RESPECT | AMPLIFY | REVITALIZE CHAINQUI DEVELOPMENT | M Z A | 2005 5TH AVE | LPB | DONH-COA-00057 | 08/03/2022 5

Re: 5th and Virginia - Full exterior façade restoration and renovation. South and East Elevations

ARC 1 2017-08-30

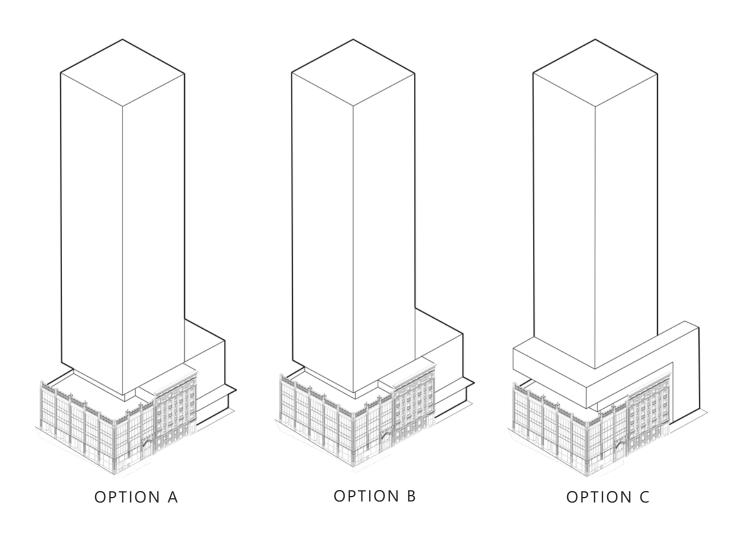
FINANCIAL FEASIBILITY ANALYSIS SHOULD BE PROVIDED TO SUPPORT THE HEIGHT

ARC 2 2018-02-02

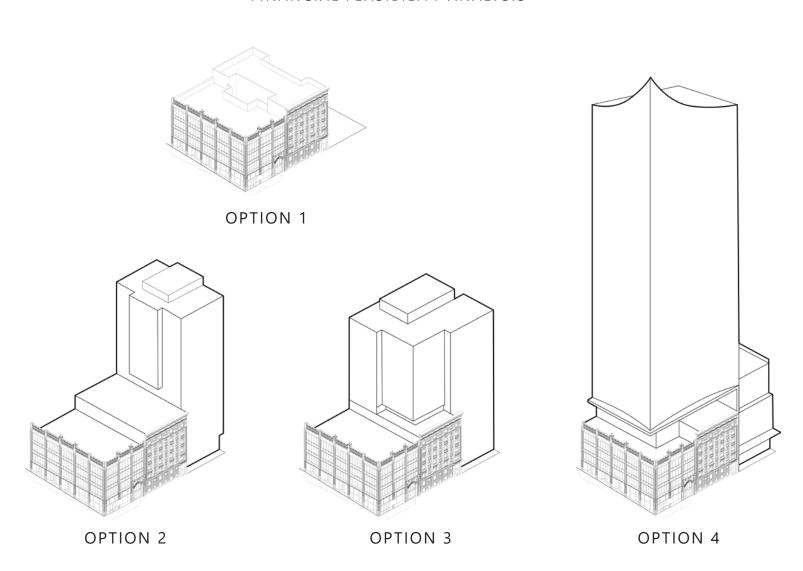
AGREEMENT THAT ALTERNATIVES ARE NOT ECONOMICALLY FEASIBLE, BUT TOWER LOCATION SHOULD BE OFF THE GRIFFIN

ARC 3 2018-06-29

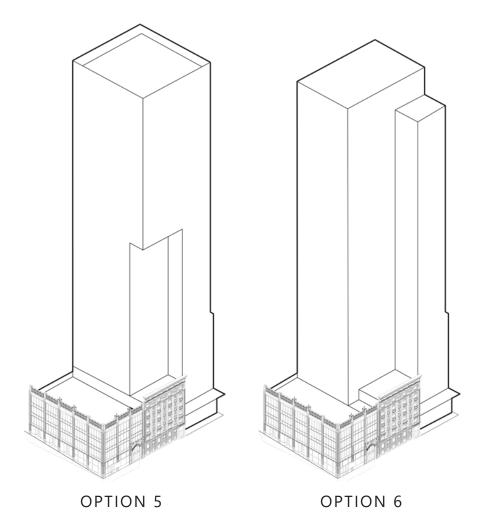
CANTILEVERING OVER GRIFFIN IS ACCEPTABLE; TOWER MASSING NEEDS IMPROVEMENT AND TOWER SEPARATION OF 32' NOT PREFERRED BY PLANNING DIRECTOR

ARC 4 2018-09-14

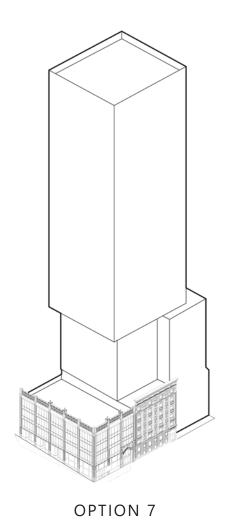
TOWER SPACING NEEDS REFINEMENT; PRESENT TO LPB

LPB 2019-03-20

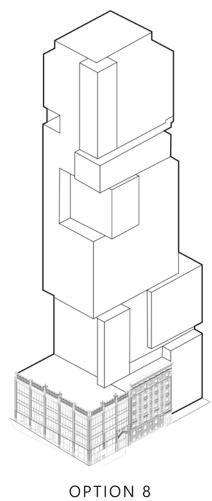
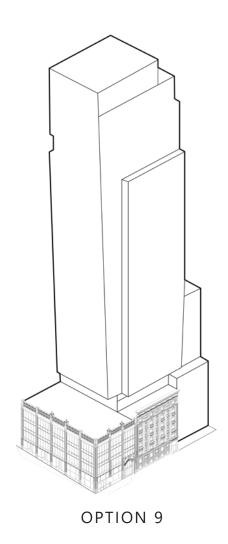
TOWER FACADE SHOULD ECHO THE RHYTHM AND VERTICALITY OF GRIFFIN BUILDING

BRING NEW TOWER TO STREET LEVEL, CREATE FRAMES TO ECHO GRIFFIN'S VERTICALITY

ARC 5 2019-09-13

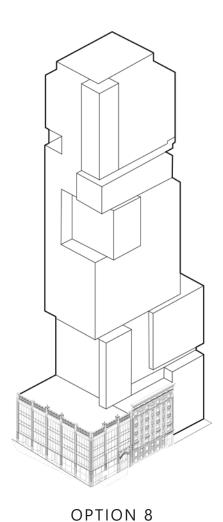
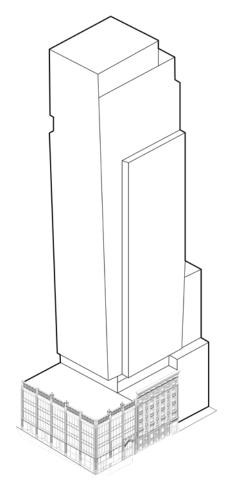
THE STEPPED EDGE IS NOT WORKING IN THIS SITUATION.

PREFERRED OPTION.
THE BOARD SUPPORTS THE 45'
TOWER SEPARATION ASSUMING THE
GRIFFIN BUILDING IS PRESERVED.

ARC 6 2020-12-11

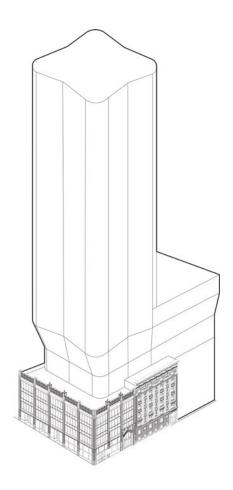
- APPRECIATED THE PROPOSED REHABILITATION OF THE LANDMARKS.
 SUGGESTED STUDYING AN NEW FORMALISM CONCEPT WAS WELL RECEIVED.
- APPROVED THE INTEGRATION OF BOTH LANDMARKS INTO THE
 REQUESTED IMAGERY DESIGN, INCLUDING UNDERGROUND PARKING BELOW GRIFFIN.
- APPRECIATED THE FUNCTION OF GRIFFIN AND SHERIDAN REMAINING AS OFFICE AND RESIDENTIAL RESPECTIVELY.
- OPTION WITHOUT THE TAPER.
- WITHOUT CLOUDS AND SUN OBSCURING THE DESIGN.

LPB 2021-02-17

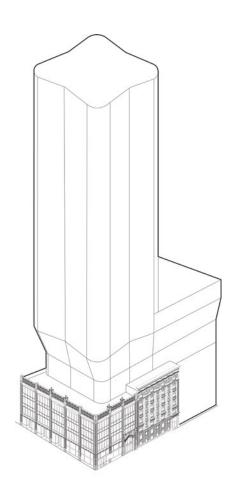
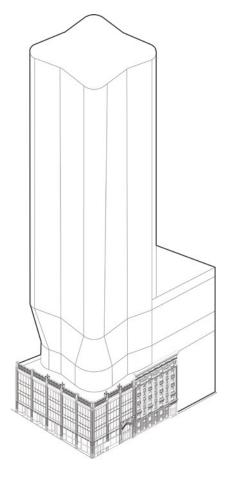
- APPRECIATED THE OPTION 10.
- APPRECIATED THE STREET LEVEL VIEW DESIGN AND "TREE" IDEA.
- SUPPORTED WITH THE ORIGINAL COLUMNS RE-CREATED
- REQUESTED MORE STUDY ON THE INTERIOR LAYOUT TO BETTER REFLECT THE ORIGINAL VOLUMES OF THE STRUCTURES.

EDG 2 2021-09-13

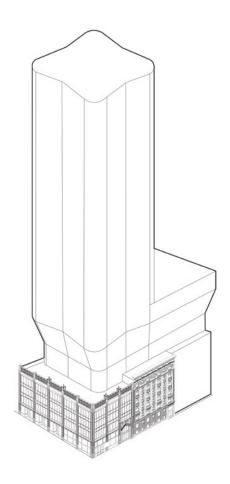
- APPRECIATED THE NEW FORMALISM DESIGN CONCEPT.
- REQUESTED FURTHER STUDY ON TOWER-PODIUM TRANSITION.
- REQUESTED FURTHER STUDY ON PODIUM TO SIMPLIFY THE FACADE EXPRESSION.
- REQUESTED FURTHER STUDY ON TOWER TERMINUS TO EXPRESS MORE OF NEW FORMALISM CONCEPT.
- REQUESTED 2 MORE OPTIONS OF TOWER SEPARATIONS: 70' AND

EDG 3 2022-01-04

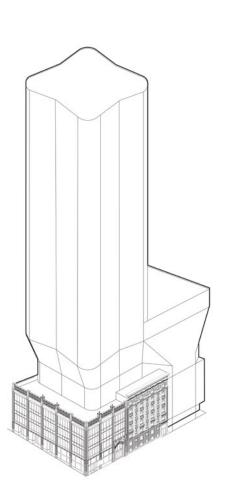
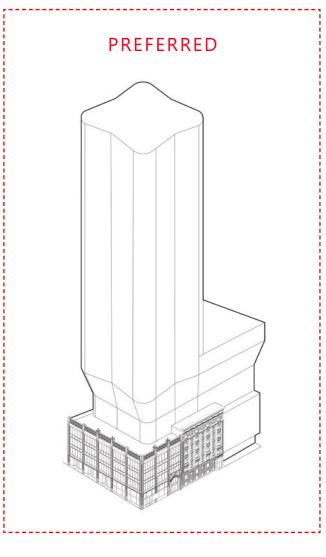
- SUPPORTED THE 60' TOWER SEPARATION.
- SUPPORTED BRINGING THE TOWER LANGUAGE TO NORTH PODIUM
- SUGGESTED TO INCORPORATE A GASKET BETWEEN THE PODIUM AND TOWER.
- AND/OR SETTING BACK THE PODIUM TO ALLOW THE CORNERS TO BE BETTER EXPRESSED.
- SUPPORTED THE DIRECTION OF TOWER TERMINUS DESIGN.
